CITY OF ALBUQUERQUE

Re: New Townhomes
624 Stover Ave. SW
Traffic Circulation Layout
Architect's Stamp 10-24-23 (K14-D038)

TRAFFIC CIRCULATION
LAYOUT APPROVED

TRAFFIC CIRCULATION LAYOUT

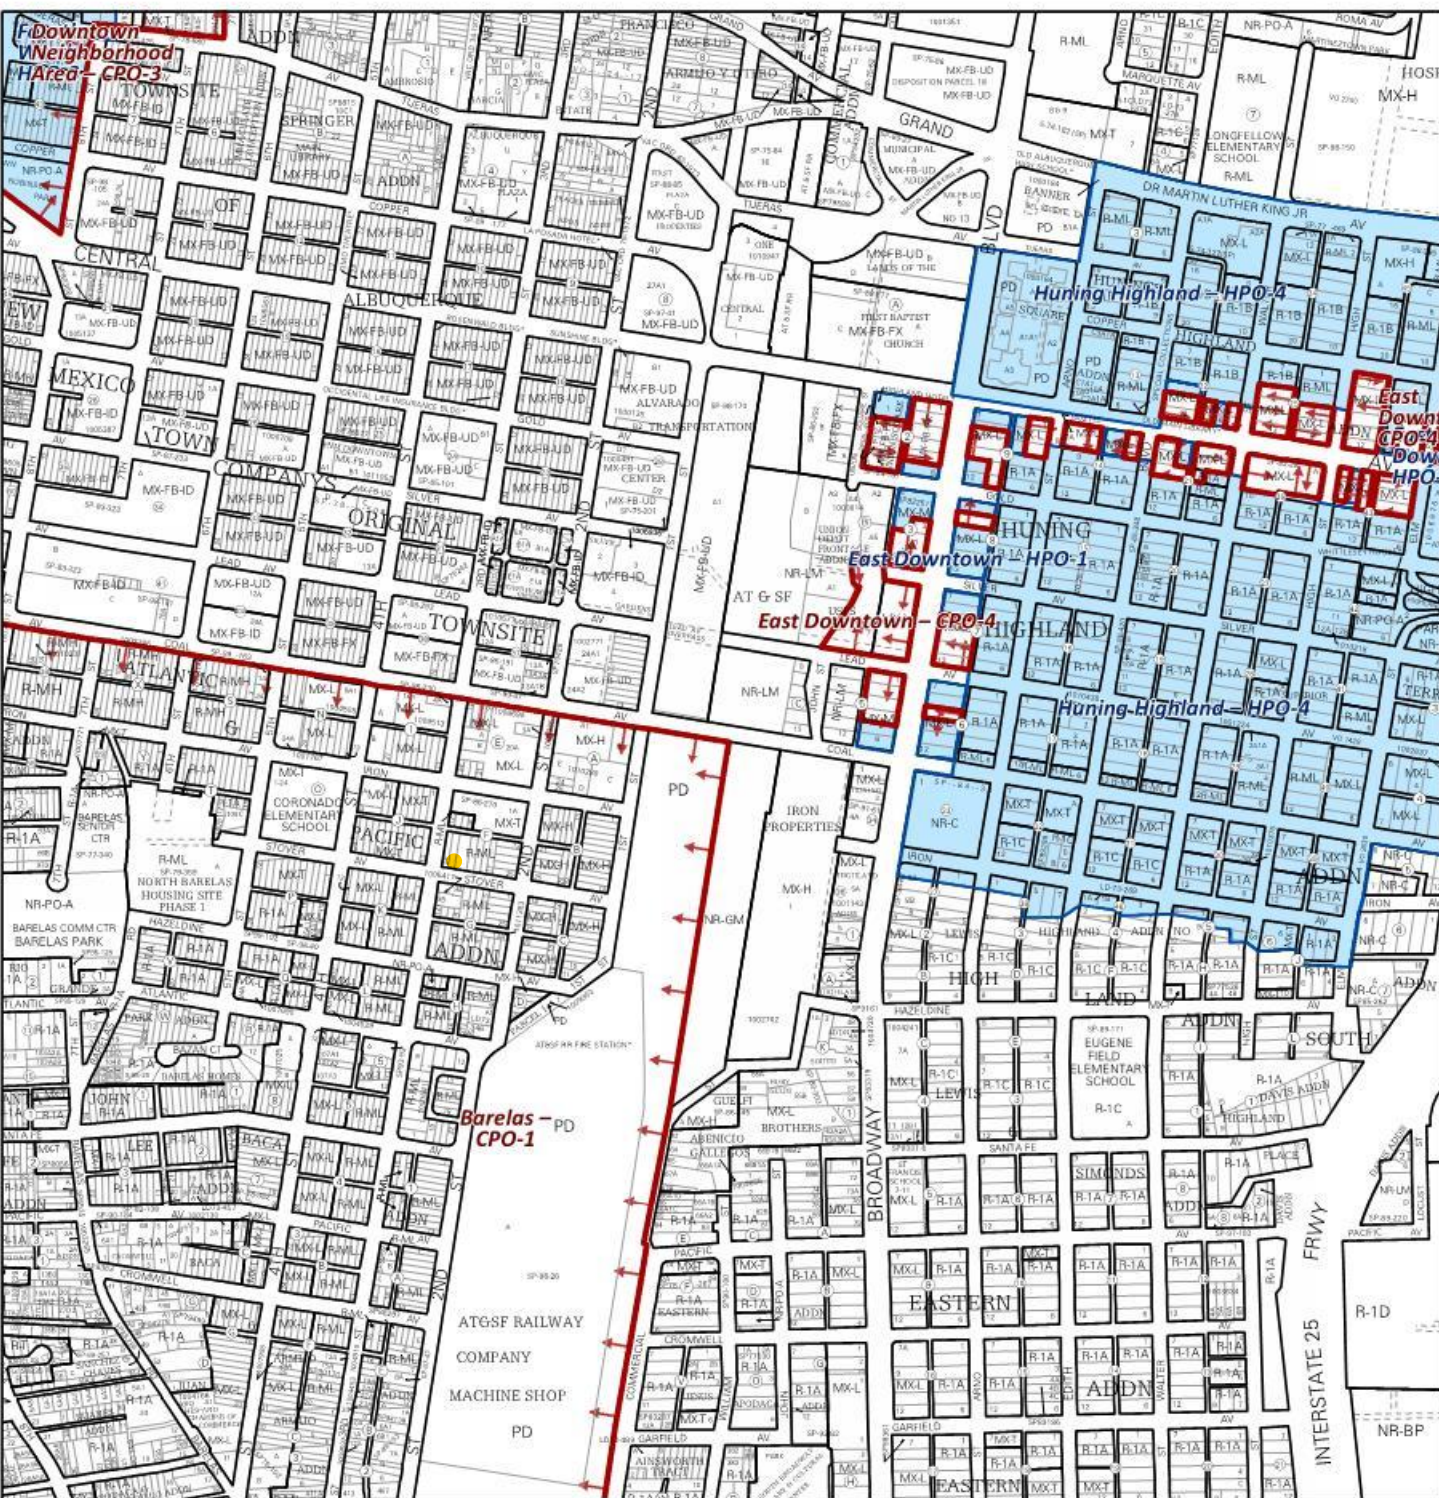
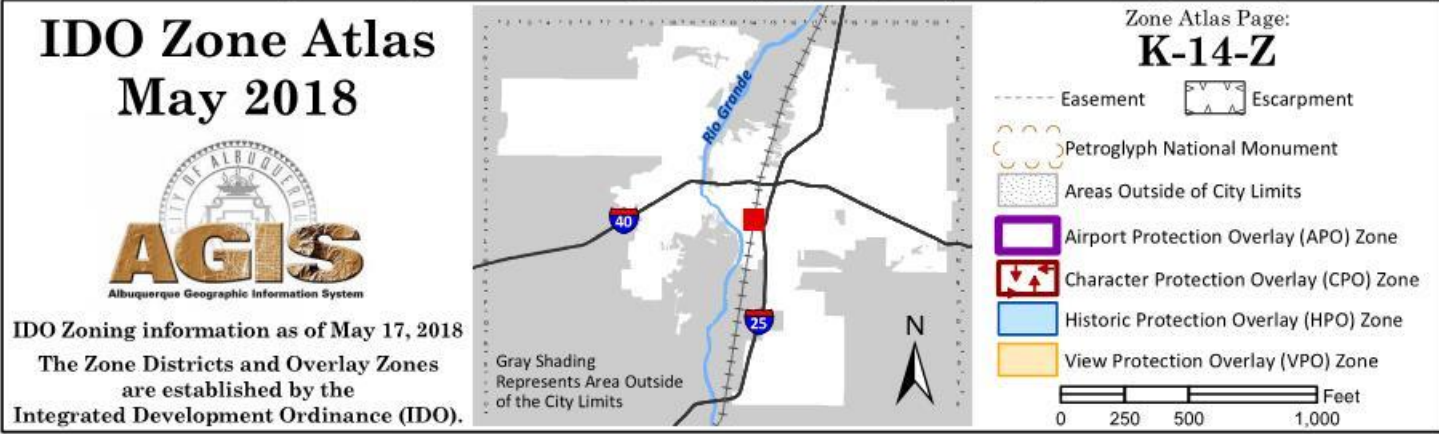
The TCL submittal received 10-25-2023 is approved for Building Permit by Transportation. A copy of the stamped and signed plan will be needed for each of the building permit plans. Please keep the original to be used for certification of the site for final C.O. for Transportation.

Unused Curb Cuts must be replaced w/ sidewalk, curb & gutter
per City standard drawing 2430 & 2415A

All broken or cracked sidewalk must be replaced with sidewalk
and curb & gutter per City standard drawing 2430
Standard C & G
